S415-01

SERVICE**TECHNICAL BULLETIN****AM Interference –
Relocate Trunk Harness –
Service Modification**MODEL 2000 MY
S-TYPE

VIN L00001-L77674

ILLUSTRATION 1

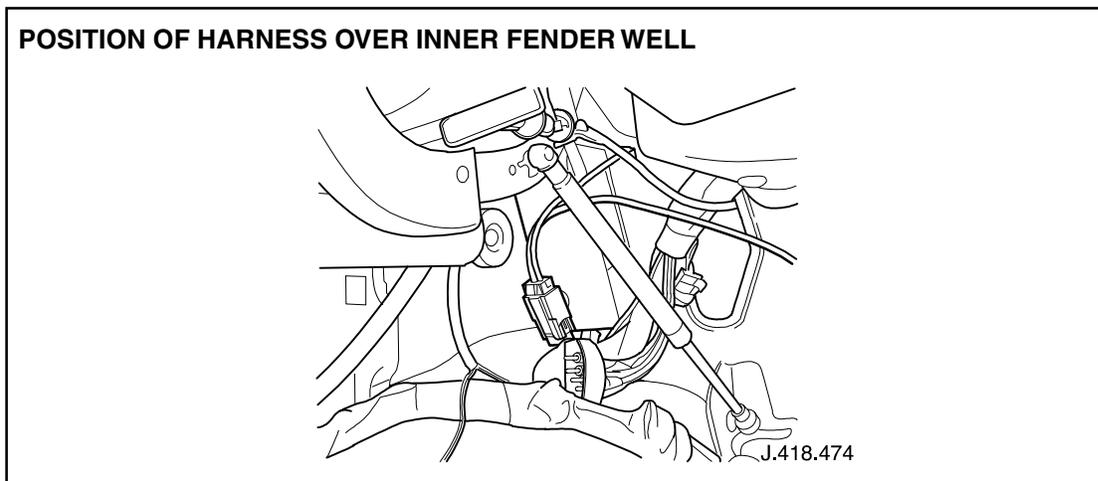
8. Reseal the main body harness while taping back the Navigation system, Voice Activation and SCP (Standard Corporate Protocol) connectors as far away from the Hidden Antenna Module as possible. Do not secure the harness to its original mounting points. Allow the harness to lie over the inner fender well as in Figure 1.

ILLUSTRATION 2

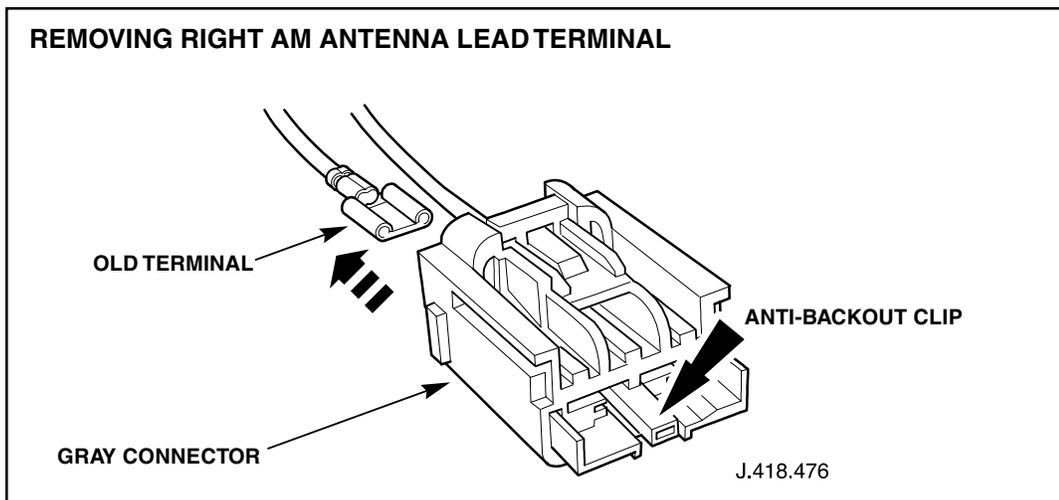
1. Disconnect the hidden antenna module antenna lead wires. Carefully remove the D-post trim above the right passenger seat. Determine which of the black wires in the gray connector connects to the right AM grid connector by using a digital volt-ohmmeter across the connector plug and the right hand AM grid connector.

ILLUSTRATION 3

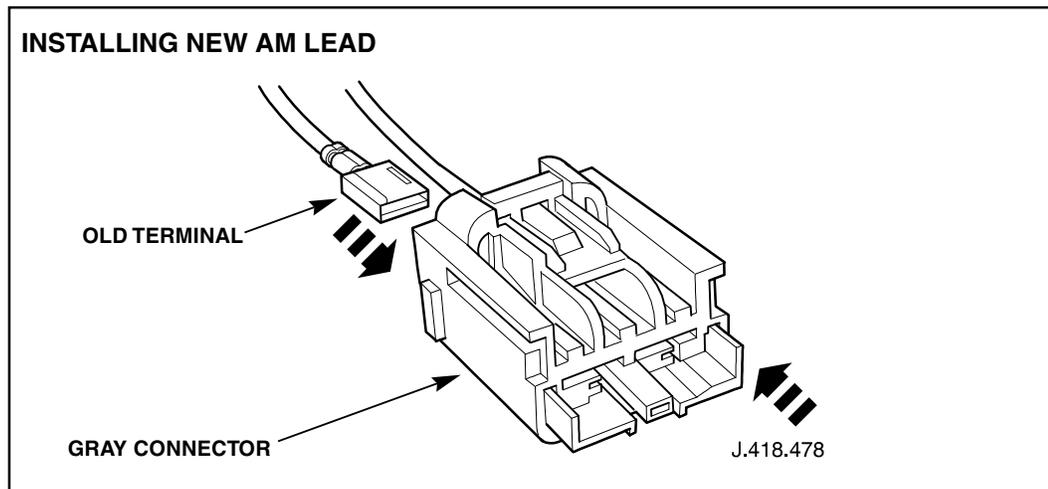
2. Once this lead has been identified, it must be removed from the gray connector. First pull out (do not remove) the white anti-backout clip as in illustration 2 and illustration 3.
3. Release the terminal by depressing its clip inside the front of the connector with a small screwdriver. Tape up the loose terminal from the connector and place the terminal behind the body cavity foam next to the hidden antenna module. Replace this lead with the new AM antenna lead.

ILLUSTRATION 4

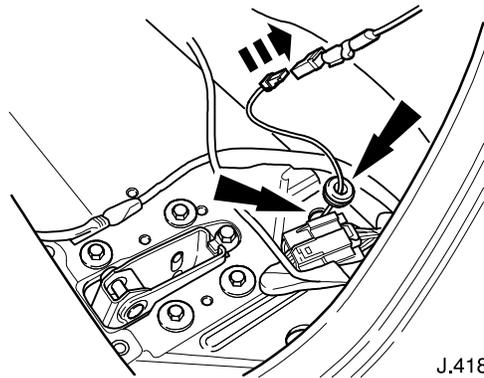
4. Gain access to the right hand side of the luggage compartment to feed the new AM lead through the desired hole in the body as shown in Illustration 4. View is from the right rear looking through the backlight.
5. Loosen (do not remove) the parcel tray, install the grommet in the hole to be used for the new AM lead, remove the gray body cavity foam from the right bulkhead hole and maneuver the black plastic connector up through the hole under the parcel shelf in the body.
6. Pull the black plastic connector underneath the trim and up the D-post to the AM antenna grid connection.
7. Disconnect the old lead and tape off to the side.
8. Run the new lead into the wires already in that pillar and connect the AM grid connector.

ILLUSTRATION 5

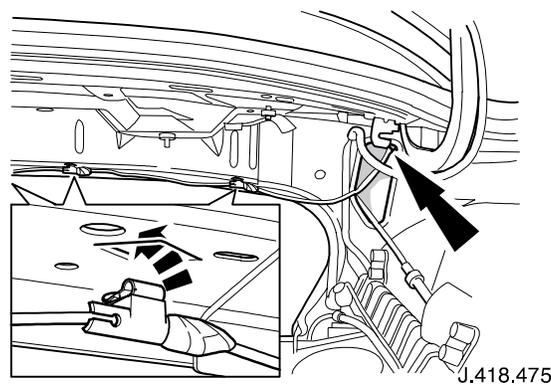
10. Secure the new AM lead with the supplied clips as shown in Illustration 5.

ILLUSTRATION 6

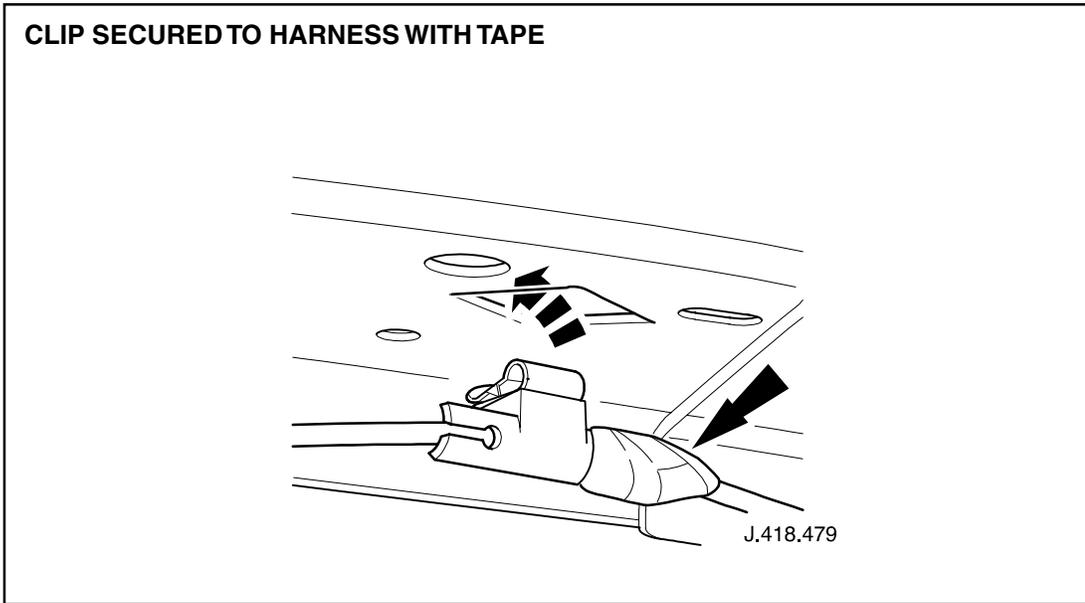
11. Secure the clip to the harness using a suitable adhesive tape (Illustration 6).
12. Reinstall all interior trim in the reverse order of removal.
13. Reconnect the battery. Refer to JTIS section 414-01 SRO 86.15.01.
14. Reset all customer settings to preferred settings as previously noted in step 1.
